Subject: Duke Energy Corporation

McGuire Nuclear Station, Units 1 and 2
Docket Numbers 50-369 and 50-370

License Amendment Request for
Technical Specification 3.6.14, CONTAINMENT
SYSTEMS, Divider Barrier Integrity - Response to
Request for Additional Information

Response to NRC Request for Additional Information on Containment Divider Barrier Integrity

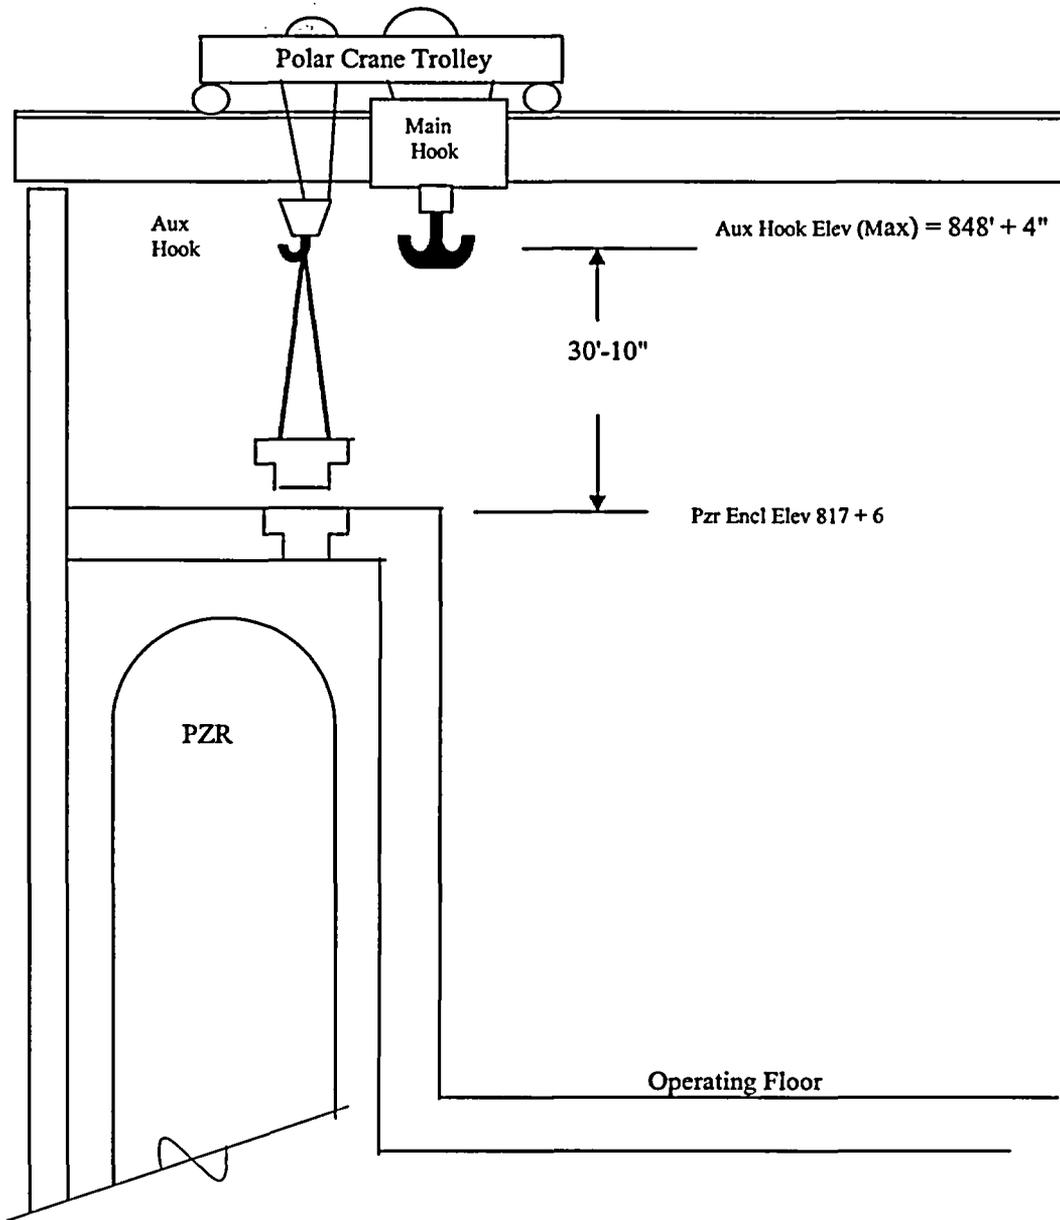
A McGuire engineering calculation was performed to ensure that the drop of the largest pressurizer hatch plug on the pressurizer enclosure roof or operating floor, and a drop of the polar crane load block on to the operating floor would not damage any equipment, component, or systems necessary for safe shutdown. ... Based on this calculation, the operating floor and the pressurizer enclosure roof can withstand a drop of the largest pressurizer enclosure hatch plug or the polar crane load block. Subsequently the heavy load drop analysis was revised to ensure the calculation enveloped the case of the largest pressurizer hatch plug dropping back into the hole.

- a. Describe the assumptions and methodology used in the above revised calculation for the NRC staff's review.
- b. Explain how the load drop analysis conforms to the NUREG-0612, Appendix A guidelines for analysis of postulated load drops. Specifically, address NUREG-0612, Appendix A, Section 1, Items 1, 3, 6, and 7.
- c. NUREG-0612, Appendix A, Section 2, Item 1 recommends that the impact loads should include the load, the crane load block, and other lifting apparatus. However, your analysis involves dropping of the

largest pressurizer hatch plug and the polar crane load block *separately* on structures. Explain how you determine consequences of a postulated load drop involving a drop of the load, the crane load block, and other lifting apparatus *together* on structures.

See the report provided as Attachment 2 in this submittal package. This report summarizes an analysis performed to support this LAR. The analysis is based on a calculation that was performed in accordance with the requirements for performing such analyses as described in NUREG-0612. The analysis does not assume a drop of the pressurizer hatch and the main hook load block since the pressurizer hatches are lifted with the auxiliary hook, not the main hook.

1. It is assumed that the polar crane auxiliary hook is in the highest position prior to a postulated load drop. The auxiliary hook is at Elevation 848'-4".
2. It is assumed that the pressurizer hatch falls back into the hatch opening, and then the auxiliary hook falls on the center of the hatch. The impacts occur at different times. Note: The rigging is made up of slings, and there is not a below the hook lifting device that would make a rigid link between the pressurizer hatch.
3. The frontal impact area of the auxiliary hook is assumed to be 0.1 sq ft.
4. The pressurizer hatch plug falls back into the pressurizer hatch opening without yielding the rebar.

- a. Concrete Strength = 5000 psi (C1 or C2, References 3.7 and 3.12)
- b. Maximum Elevation of Polar Crane Auxiliary Hook = 848'-4" (Reference 13)
- c. Elevation of top of pressurizer cavity = 817'-6"
- d. Polar Crane Auxiliary Hoist Load Block Weight = 1000 lbs
